ECE/TRANS/WP.29/GRSP/2008/11  
5 March 2008

REGULATION No. 17  
(Strength of seats)

Alignment to the draft gtr on head restraints

Submitted by the expert from the European Commission (EC) \*/

Figure 1. Non-use warning labels

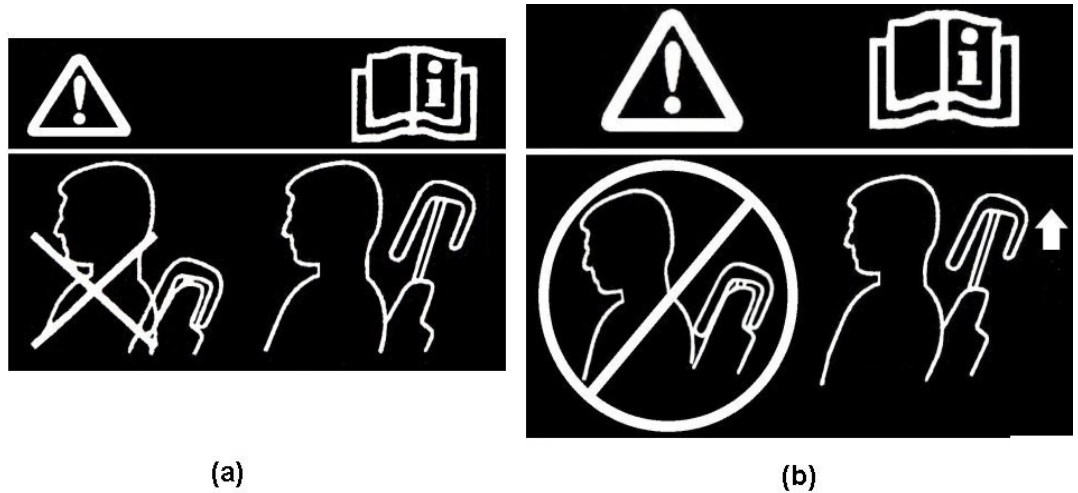
- 5.7.4.5.** The head restraint shall be marked with a label in the form of a pictogram which may include explanatory text. The label shall either provide an indication when the head restraint is in a non-use position or provide information to enable an occupant to determine whether the head restraint is in a non-use position. The label shall be durably affixed and located such that it is clearly visible by an occupant when entering the vehicle to the designated seating position. Examples of possible designs of pictograms are shown in Figure 1.

Figure 1-1

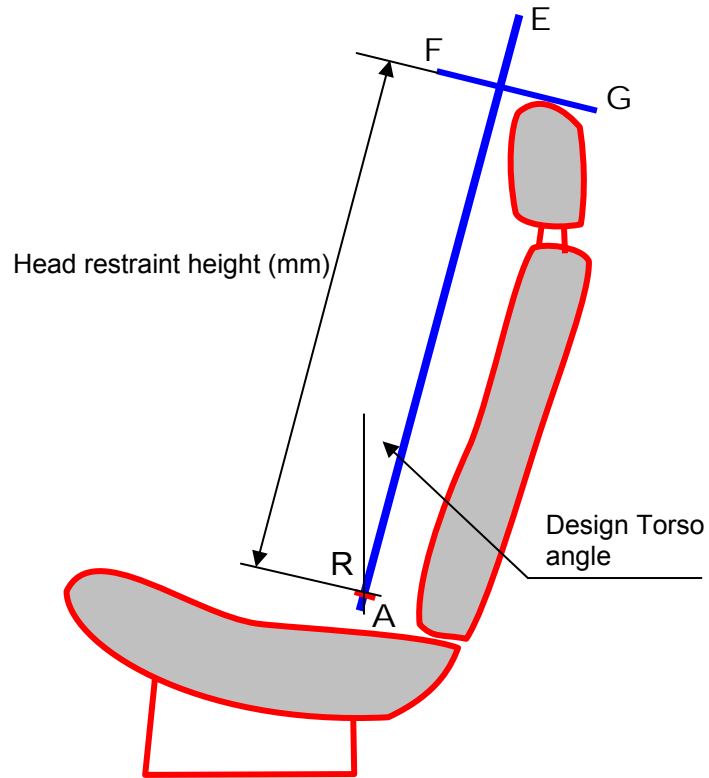
The height measurement apparatus consists of (see Figure 1-1):

- 2.4.1. If adjustable, adjust the top of the head restraint to the lowest position of adjustment intended for normal use, other than any non-use position described in paragraph 5.8. of this Regulation and measure the height.
- 2.4.2. For head restraints that are prevented by the interior surface of the vehicle roofline or rear backlight from meeting the required height as specified in paragraph 5.5.2.2. or 5.5.2.4. of this Regulation, the requirements of paragraphs 5.5.2.3. and 5.5.2.5. shall be assessed by the following procedure:

- 2.4.2.1. If adjustable, adjust the head restraint to its maximum height and measure the clearance between the top of the head restraint or the seat back at all seat back angles for intended use and the interior surface of the roofline or the rear backlight, by attempting to pass a  $25 \pm 0.5$  mm sphere between them. In the case of convertibles, the diameter of the sphere shall be  $50 \pm 0.5$  mm.

Figure 2-1

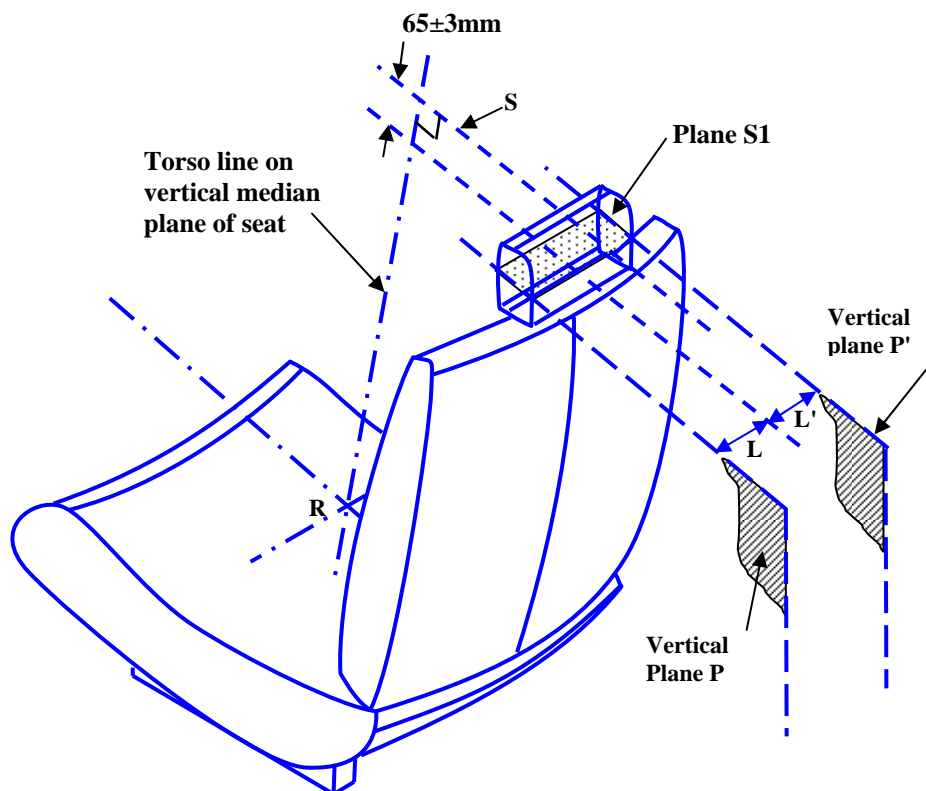
- 2.1. The seat shall be adjusted such that its H-point coincides with the R-point; if the seat back is adjustable, it is set at the design seat back angle; both these adjustments shall be in accordance with the requirements of paragraph 2.1. of Annex 1.
- 2.2. The plane S1 is a plane perpendicular to the reference line and situated  $65 \pm 3$  mm below the top of the head restraint.
- 2.3. Planes P and P' are vertical longitudinal planes, tangent to each side of the head restraint to be measured.
- 2.4. Measure the distances L and L' in the plane S1 between the vertical longitudinal planes passing through the torso line and the planes P and P'.

Figure 3-1 - Measurement of a horizontal gap "a".

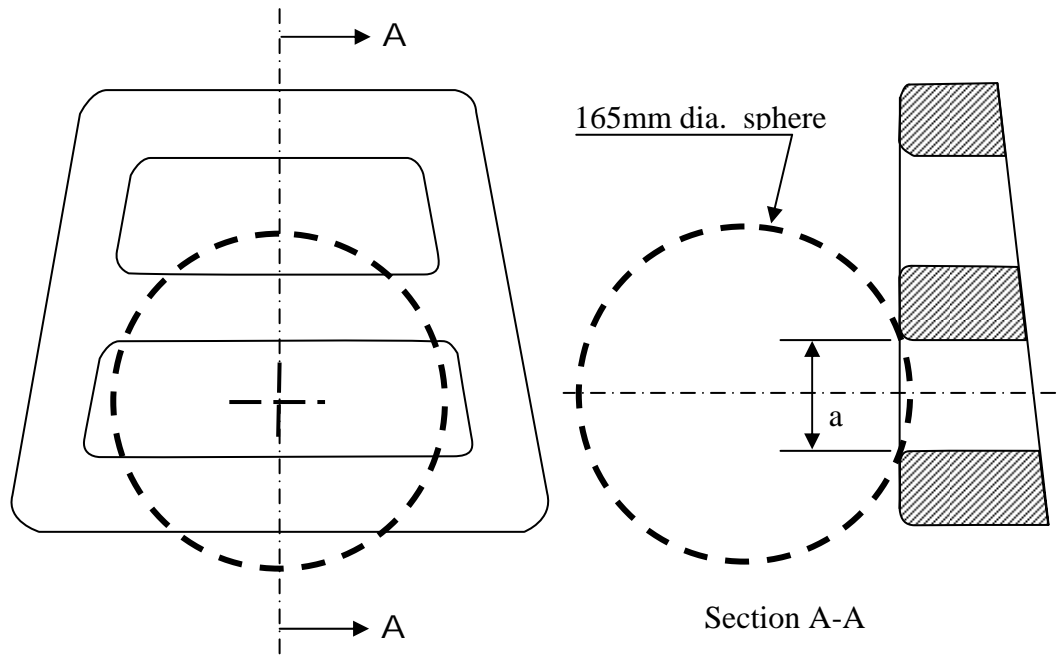
- 2.6. For gaps within the head restraint, not exceeding 60 mm, no further measurements shall be made.

- 2.7. For gaps within the head restraint, exceeding 60 mm, in order to demonstrate compliance with the requirements of paragraph 5.5.5. of this Regulation, the seat back displacement test procedure described in Annex 6 shall be performed, by applying to each gap, using a sphere of 165 mm in diameter, a force passing through the centre of gravity of the smallest of the sections of the gap, along transversal planes parallel to the torso line, and reproducing a moment of 373 Nm about the R-point.

Figure 3-3

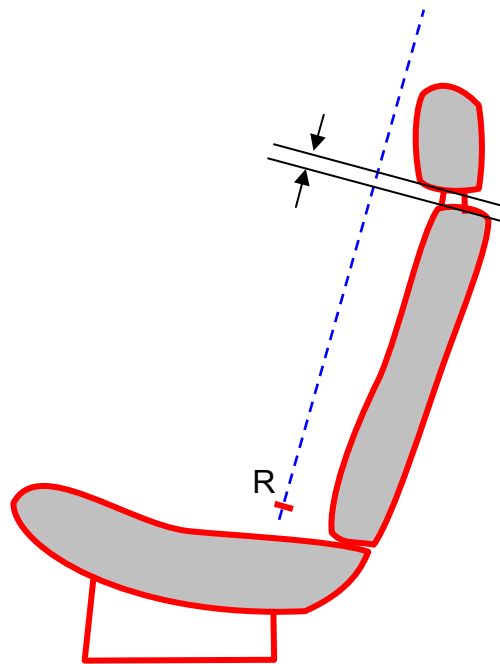
**3.3.** The gap shall be measured as the perpendicular distance between two parallel planes, described as follows (see Figure 3-3):

- (a) each plane shall be perpendicular to the design torso line;
- (b) one of the planes shall be tangent to the bottom of the head restraint;
- (c) the other plane shall be tangent to the top of the seat back.

Figure 4-1

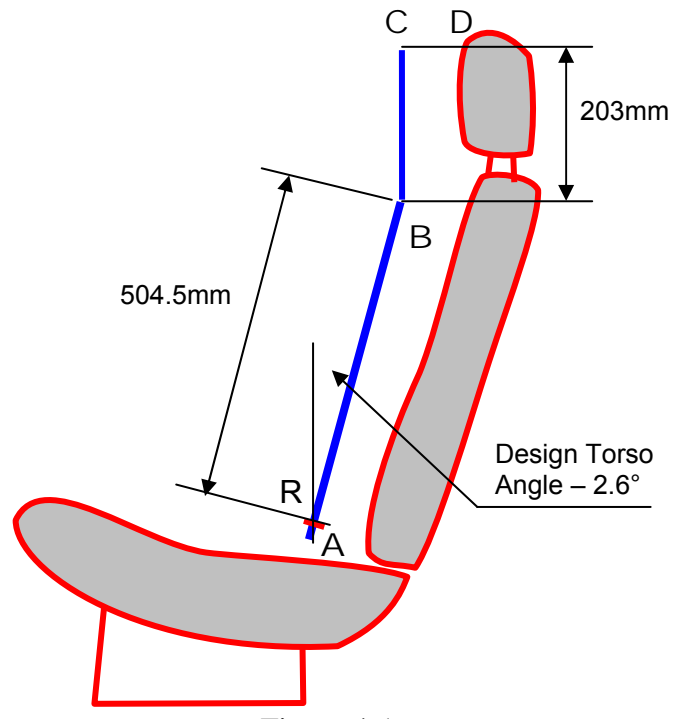
The backset measurement apparatus consists of (see Figure 4-1):

**3.6. Establish point D on the head restraint, point D being the intersection of a line drawn from point C horizontally in the x-direction, with the front surface of the head restraint.**

**3.7. Measure the distance CD. The backset shall be the measured distance CD minus 71 mm.**

Figure 6-1.

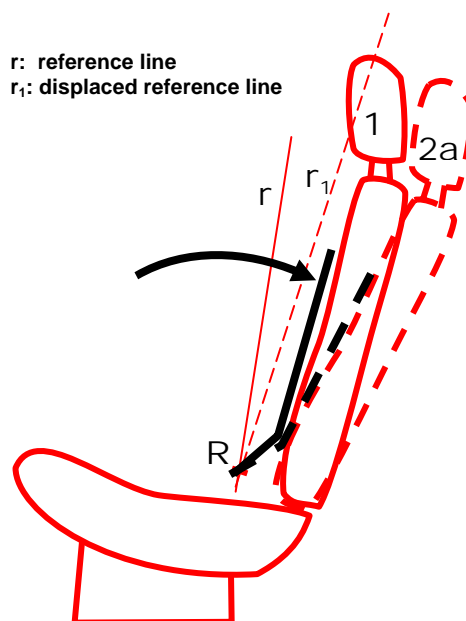
2.3. Establish the displaced torso reference line 'r' by creating a rearward moment of  $373 \pm 7.5$  Nm about the R-point by applying a force to the seat back through the back pan at the rate of 2.5 Nm/second to 37.3 Nm/second. The initial location on the back pan of the moment generating force vector has a height of  $290 \text{ mm} \pm 13 \text{ mm}$ . Apply the force vector normal to the torso reference line and maintain it within 2 degrees of a vertical plane parallel to the vehicle longitudinal centreline. Constrain the back pan to rotate about the R-point. Rotate the force vector direction with the back pan. (see Figure 6-1)

Position 2a. Displaced position by applying to the manikin's back a moment of  $373 \pm 7.5$  Nm about the R-point, defining the position of the displaced torso reference line 'r<sub>1</sub>'.

Figure 6-2.

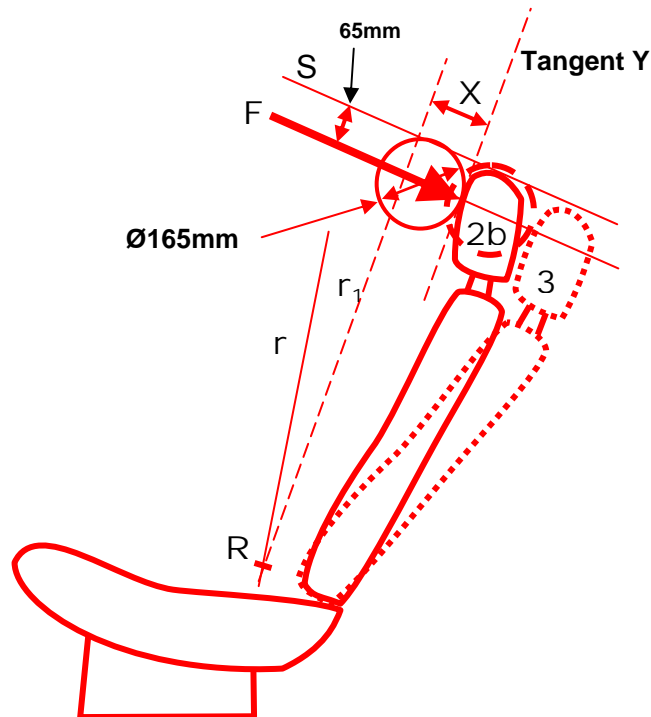
- 2.4. Maintain the position of the back pan as established in paragraph 2.3. of this annex. Using a  $165 \pm 2$  mm diameter spherical headform establish the headform initial reference position by applying, perpendicular to the displaced torso line, a rearward initial load at the seat centreline at a height  $65 \pm 3$  mm below the top of the head restraint that will produce a  $373 \pm 7.5$  Nm moment about the R-point. Maintain this moment for at least 5 seconds and then record the rearward displacement of the headform with the load applied.
- 2.5. When determining the rearward displacement for head restraints at a gap greater than 60 mm in accordance with paragraph 5.5.4 of this Regulation, the above load shall be applied through the centre point of the smallest of the sections of the gap, along transversal planes parallel to the torso line (see Figure 6-2).

Figure 10-1.

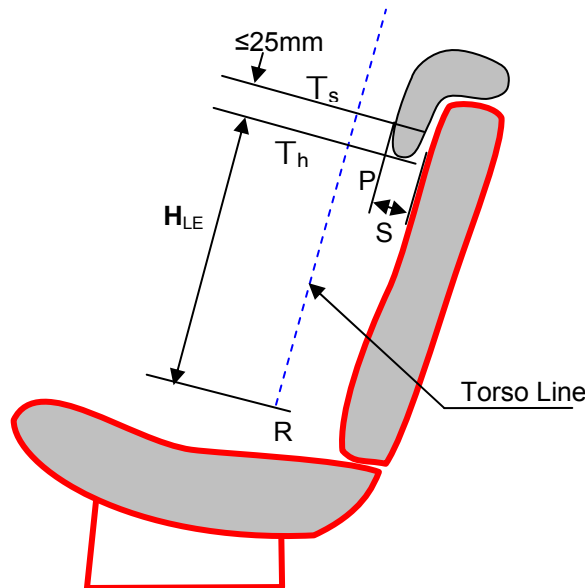
4.1. The HLE and S dimensions are defined in Figure 10-1 which shows a vertical fore-aft plane passing through the R-point (i.e. at the mid point of the designated seating position) intersecting the seat cushion, seat back and the head restraint.

4.2.4. **TH is the line perpendicular to the torso line and tangent to the lower edge of the head restraint.**

4.2.5. **TS is the line parallel to and 25 mm from TH.**
